Approvals		Date	File	
Drawn GLG		051710	TWR-S12GN32	
Checked DSR	051710	Size C	Document Number	DOC-0520-030
Finish		Date: Wednesday, May 26, 2010	Sheet	1 of 3

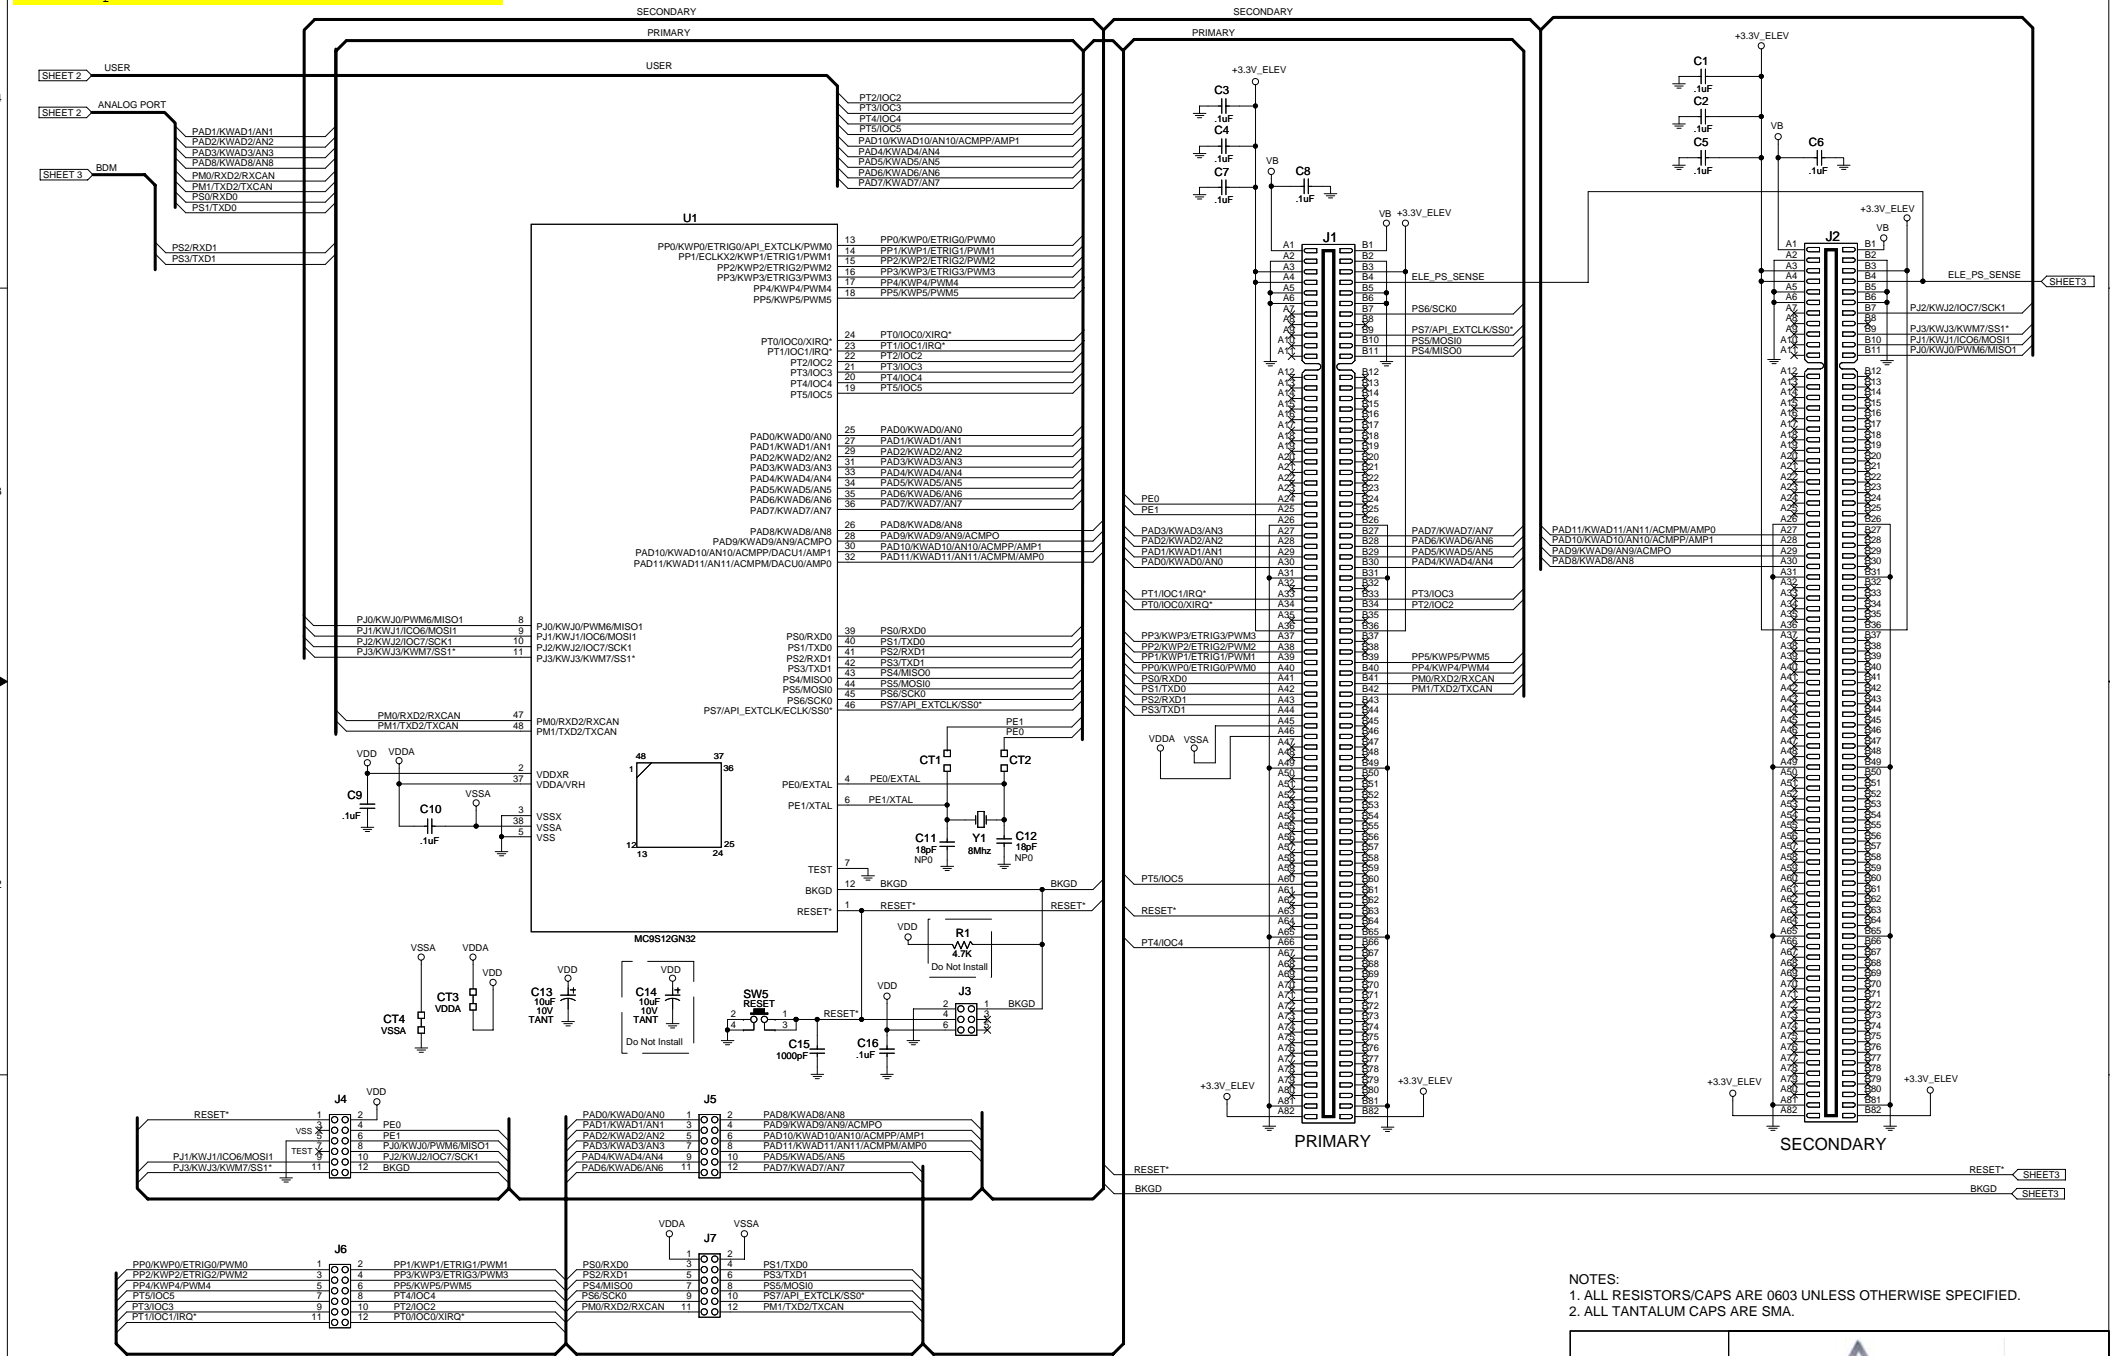
12/2011
 Signal Name at U1-30 is incorrect.
 Refer to MC9S12G Family RM for correct
 device pin-out
